PRELIMINARY SITE PLAN
PDC-98-01(P) - DAVID K. DEITRICH, AS TRUSTEE, ET AL/MARKET PLACE WEST

ATTACHMENT #1

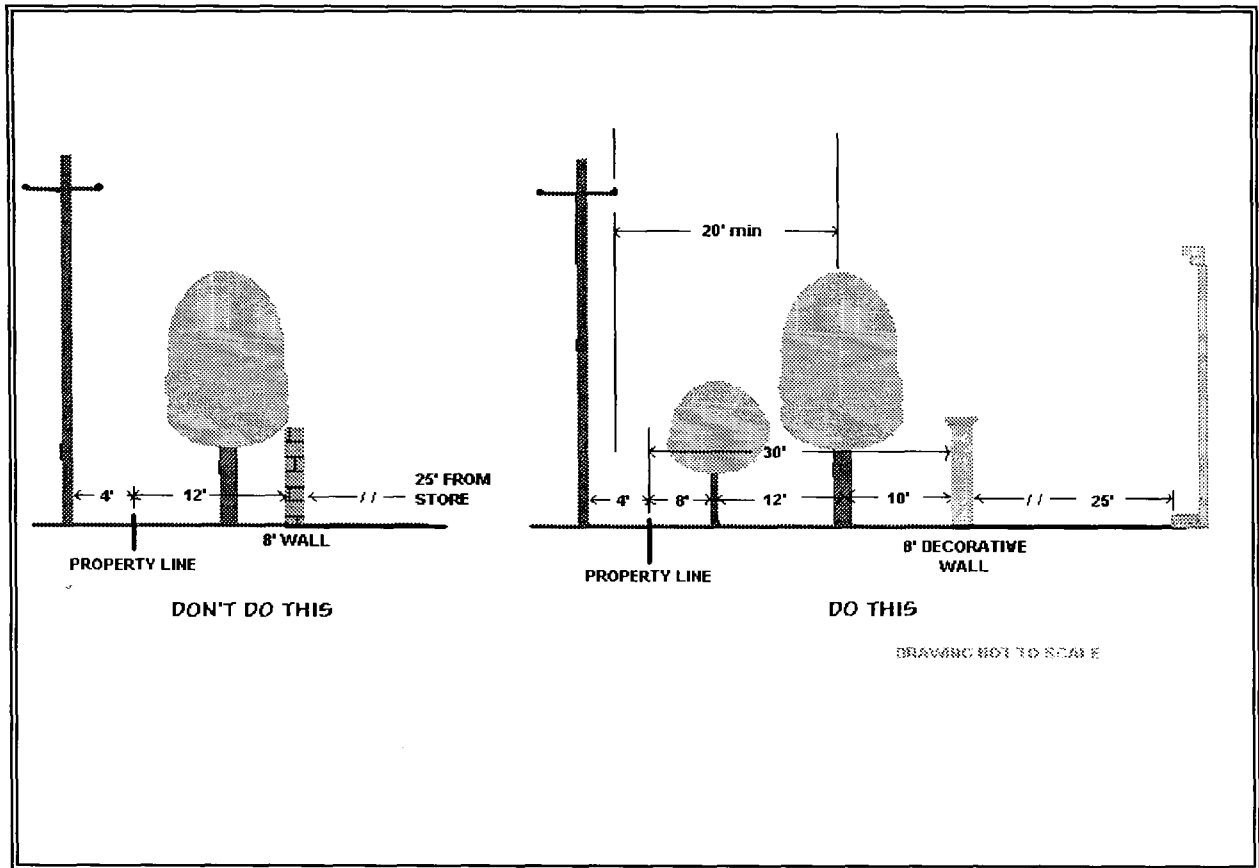
- b. As illustrated in Attachments #1 and #2, the landscaped buffer along the southern boundary shall be at least a 20' wide buffer with 2 rows of trees. This buffer shall include 1 row of canopy trees (medium trees in FPL pamphlet *The Right Tree in the Right Place*) spaced 40' apart at least 15 feet from existing power lines. In addition, one row of understory trees (small trees in FPL pamphlet *The Right Tree in the Right Place*) offset from the canopy trees and spaced 40' on-center. In addition,

the 8' wall shall include decorative elements reflective of finish building materials, colors, and architectural details of the shopping center.
